FEDERAL TRADE COMMISSION

Energy Labeling Rule

ACTION: Final rule; correction.

SUMMARY: The Federal Trade Commission ("Commission") is correcting a final rule published in the **Federal Register** of August 12, 2014, which amends the Energy Labeling Rule by updating comparability ranges for certain heating and cooling products and making conforming changes to the Rule's sample labels.

Prototype Label 3 – Single-Package Central Air Conditioner (models manufactured after the compliance date of DOE regional efficiency standards in 10 CFR part 430)

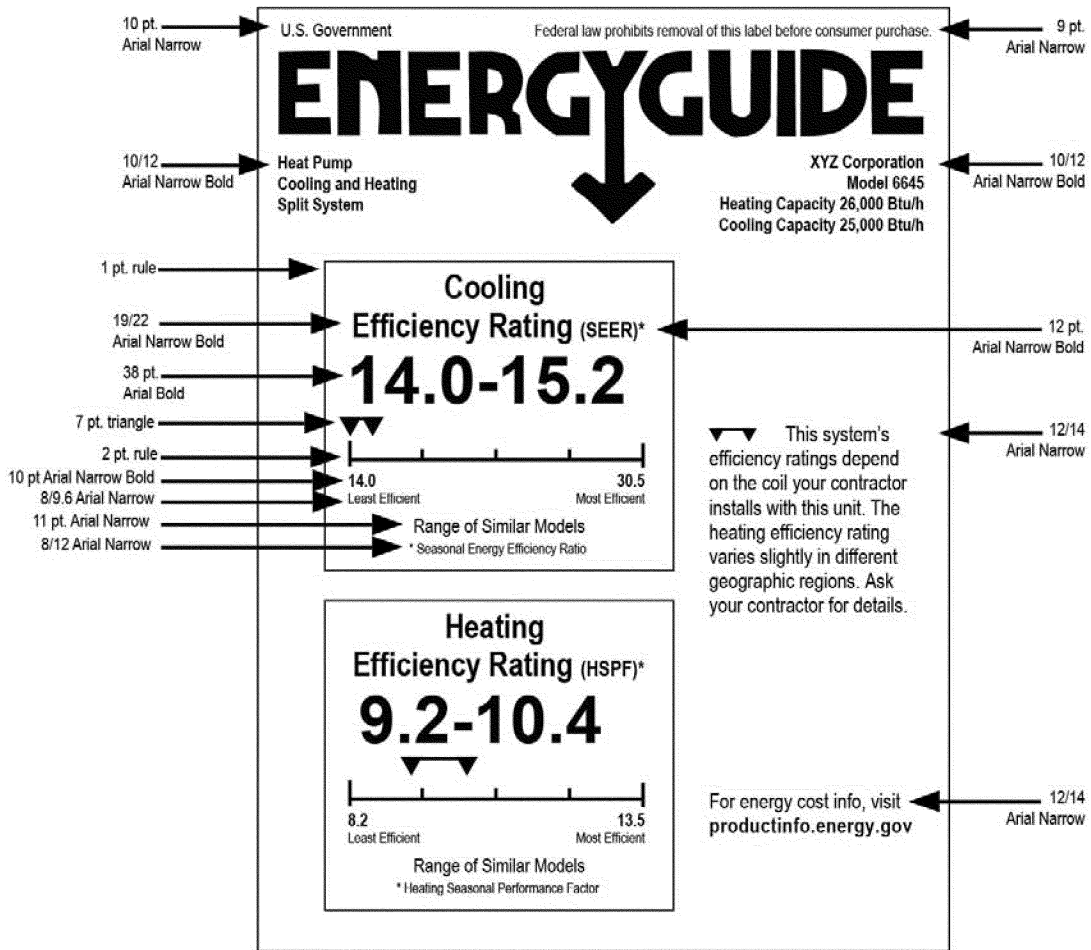
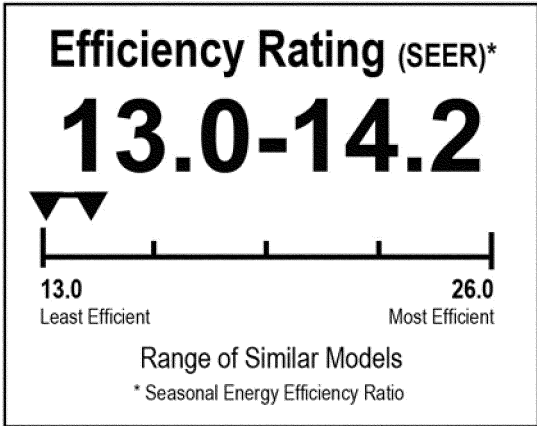
■ 3. On pages 46988 through 46992, Prototype Labels 3 and 4 and Sample

Labels 7, 7A, and 8 are corrected to read as follows:
